41 Bedford Square, London (2020/5947/P)

41 BEDFORD SQUARE (ref 2020/5947/P)

Delegated Report		Analysis sheet		Expiry Date:		16/02/2021	
(Members Briefing)		N/A / attached		Consultation Expiry Date:		20/06/2021	
Officer				Application Number(s)			
Elaine Quigley				2020/5947/P			
Application Address				Drawing Numbers			
41 Bedford Square London WC1B 3HX				See draft decision notice			
PO 3/4		Area Team Signature		C&UD		Authorised Officer Signature	
Proposal(s)							
Details of ventilation grills and louvre doors (Condition 7) as part of planning permission ref 2019/3676/P dated 28/11/2019 for partial demolition of existing link structure between 11 Bedford Avenue and 41 Bedford Square, installation of new canopy and balustrades, new walk-on rooflight to rear terrace at ground floor level, new plant to front vaults and rear lower ground floor level, removal of internal partitions and ceiling at 11 Bedford Avenue, partitions removal at basement level at 41 Bedford Square, and other internal alterations (RETROSPECTIVE).

Recommendation(s):		Approval of Details					
Application Type:		Approval of Details

Figure 4 (above): As proposed ventilation louvre at lower ground floor level on the mews building at 11 Bedford Avenue

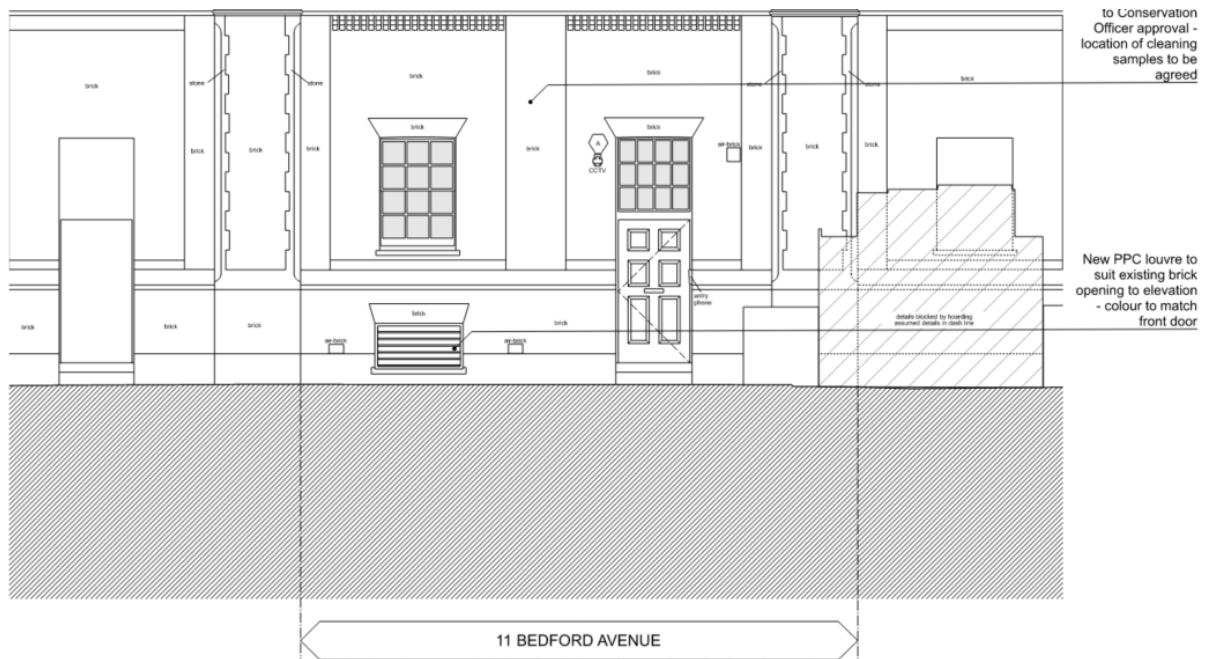
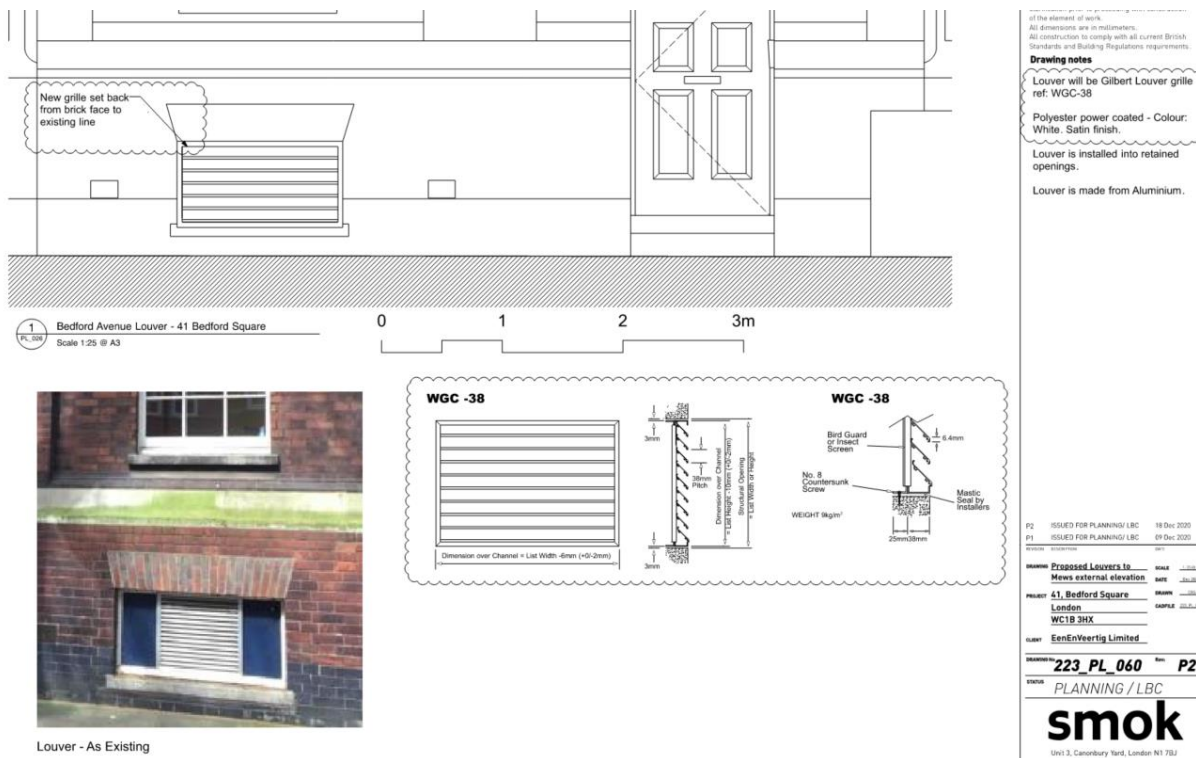
4.1 It is noted that there are discrepancies between the approved, and proposed plans and what has been installed on site. This relates to the ventilation grill at lower ground floor level on the front elevation of the mews building.

4.2 The Bloomsbury Association is concerned that the ventilation grill would not match the design illustrated in the approved plans and does not match the colour of the front door which was annotated on the approved plan and therefore doesn't comply with Condition 3 of planning permission 2019/3676/P that all materials should match the existing. The proposed plan does not reflect what has been installed on site as the louvre includes more grills has been installed. In terms of the design there is no objection to the louvres which appear to be broadly in keeping with the approved plans. Although black would have been preferable in terms of colour it must be noted that the previous louvre that was in place was white in colour and the installed louvre is also white as well as the fenestration above. The Council's conservation officer has reviewed the information and is satisfied with the details.

Figure 4 (as above): Proposed elevation and section of the lower ground floor vault louvre door

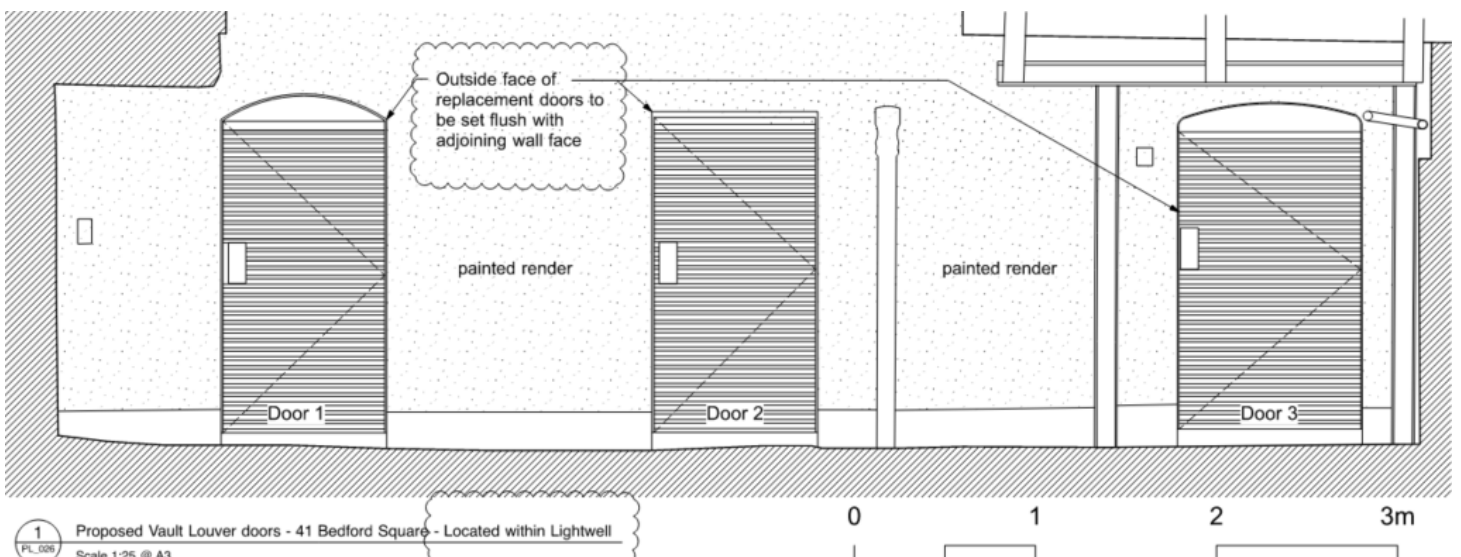
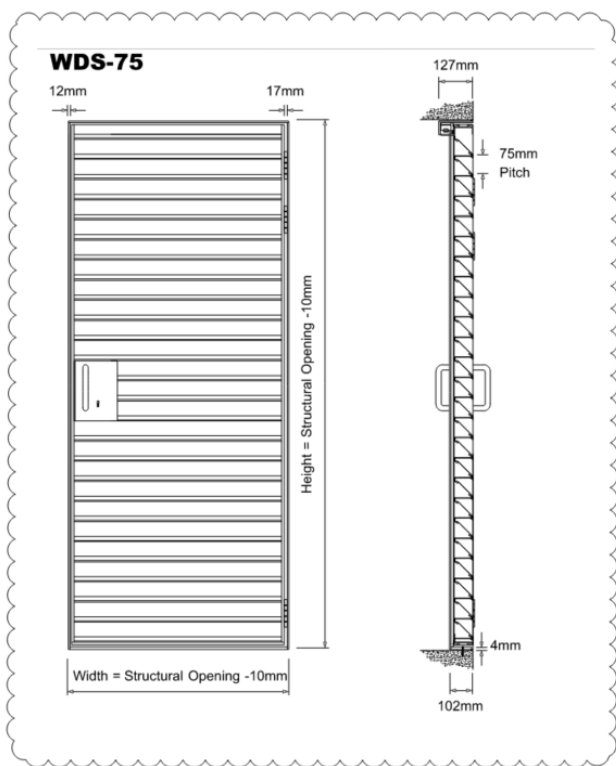
3.2 The original permission included replacement of plant equipment and louvres to the front vaults. A noise report was submitted in support of the original permission. In paragraph 7.1 of the plant noise report and technical specification for air-condenser plant the report states "*The sound reduction index requirements for the louvre are set out in Table 5 installed. This would typically only be achieved using a 270-300mm deep acoustic louvre (for example 270mm louvre by EEC Ltd. Is used in the calculations*". The proposed plans include a section of the louvre doors which shows acoustic louvre door of 102mm in width. This would not meet the requirements detailed by the acoustic consultant in the plant noise report. The Bloomsbury Society has raised this in their objection to the application.

3.3 The proposal has been reviewed by the Council's Environmental Health officer who has confirmed that the mitigation measures comply to the design criteria set out within the acoustics plant noise report (ref: A1480/R01 17/07/19). It has also been confirmed that there have been no noise complaints logged with the Council since the installation of the units. A condition has been attached to the original permission to control the noise levels of the external building services and fixed plant to ensure that it meets the Council's minimum noise standards (condition 6). Should noise from the plant exceed the Council's minimum noise standards there would be a breach of this condition which could then be investigated by the Council's Enforcement Team. In light of the above, the information is considered satisfactory, and the condition can be discharged.
